Subject: MHI's Responses to US-APWR DCD RAI No.257-1613

Responses to Request for Additional Information No. 257-1613
Revision 0

**US-APWR Design Certification
Mitsubishi Heavy Industries
Docket No.52-021**

**APPLICATION SECTION: MUAP-07021-P “US-APWR Incore Power Distribution
Evaluation Methodology”**

Figure 04.03-21-1 US-APWR INSTRUMENTATION THIMBLE AND RCCA LOCATIONS

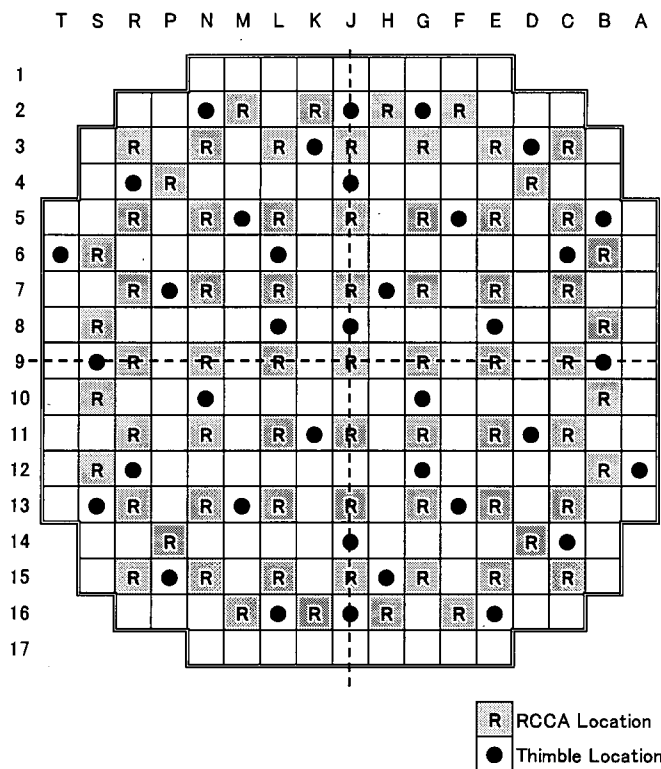
Page 3 – Specify the planes that define each quadrant of Figure 2-2. This question is asked to satisfy GDC10 requirements.

Page 3 – Clarify the statement that the thimbles are “distributed nearly uniformly in the core” and that the distribution in each quadrant is nearly identical. This question is asked to satisfy GDC10 requirements.

The instrumentation thimble and rod control cluster assembly (RCCA) locations for the US-APWR core are shown in Figure 04.03-21-1. The dotted lines along the vertical and horizontal axes (major axes) are the planes that define each quadrant.

Please refer to the Figure 04.03-21-1 in RAI Question No. 04.03-21. The following table shows the distribution of instrumentation thimble locations by quadrant. Note that out of 37 total instrumentation thimble locations, 7 are on the major axes of the core and are counted in two quadrants. Each quadrant has a similar number of instrumentation thimble locations available. Also, each instrumentation thimble is located adjacent to a control rod and the control rod pattern is symmetric and therefore the instrumentation thimbles have a nearly uniform distribution.
